MEMORANDUM

Subject: Transfer 70750, Raft River

RAFT RIVER CRITICAL GROUND WATER AREA

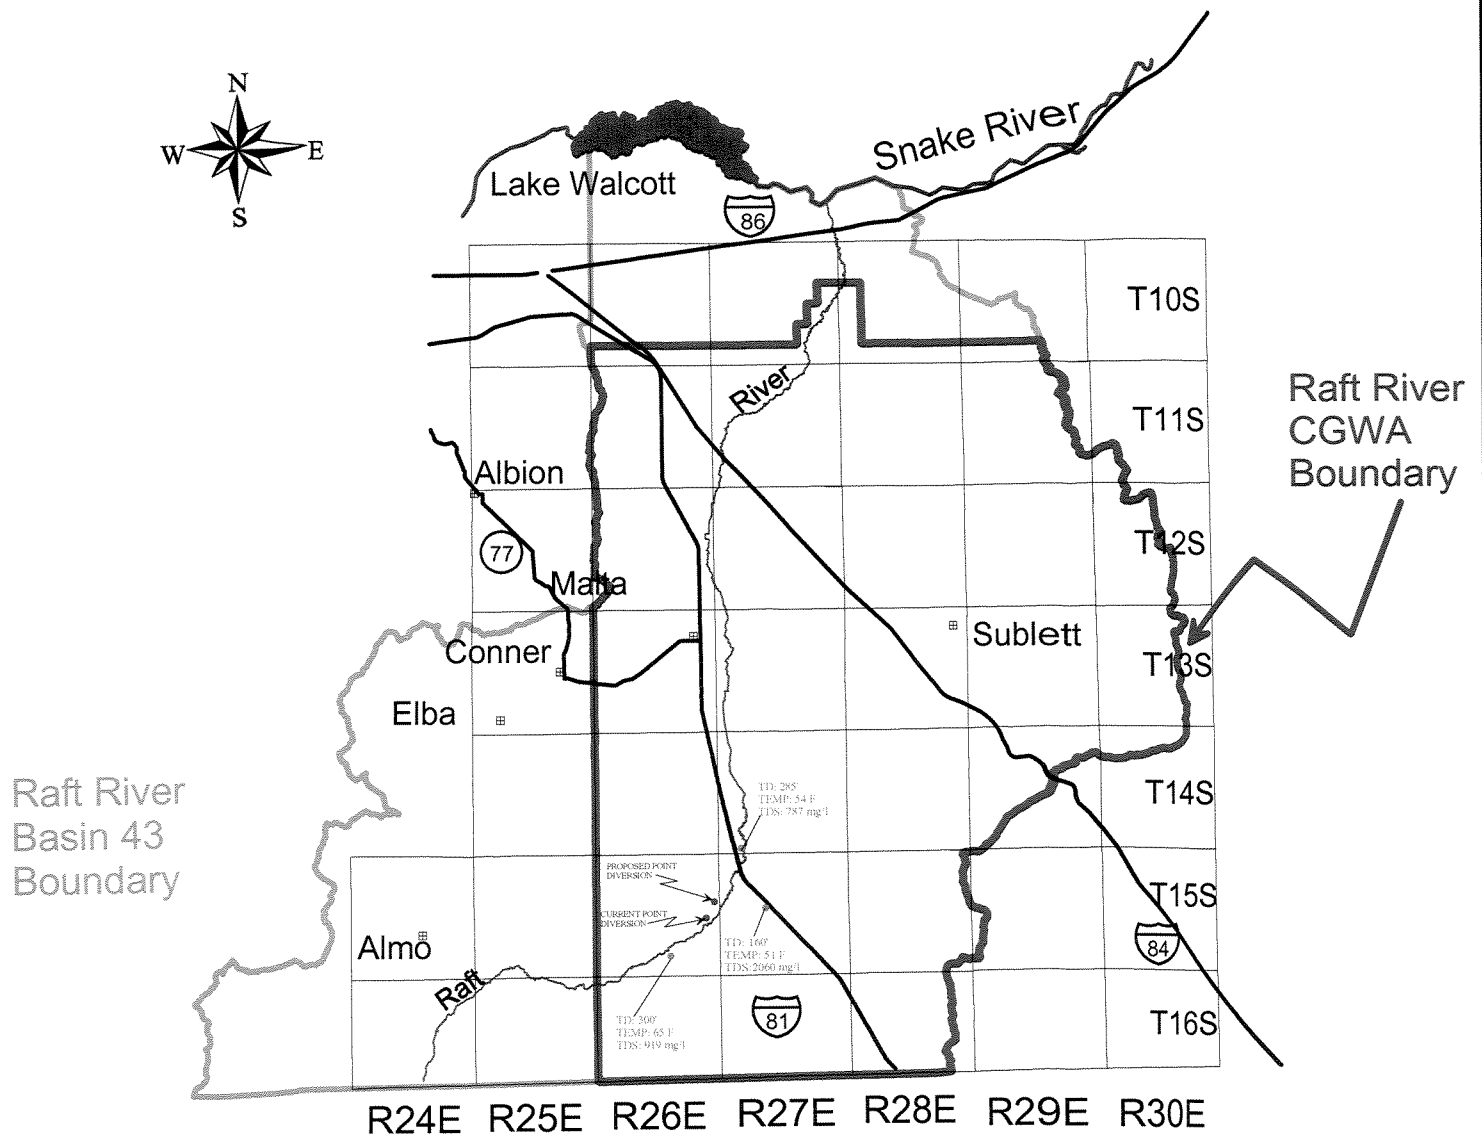
It is my understanding the applicant wishes to transfer part of his ground water right approximately 4,000 feet to the northwest (see the Attached figure). Reason for the transfer is the current well produces water too hot for irrigation. The new well hopefully produce water of a lower temperature and the mixing of the water from the two wells will be suitable agricultural use.

As a further check more recent water quality data from the regional system is shown on the attached figure. The TDS ranges from 787 to 919 mg/l.

The flow from the geothermal waters upward into the regional system is probably saturated, but data are not available to confirm this. Therefore pumping from one system will probably affect the other.
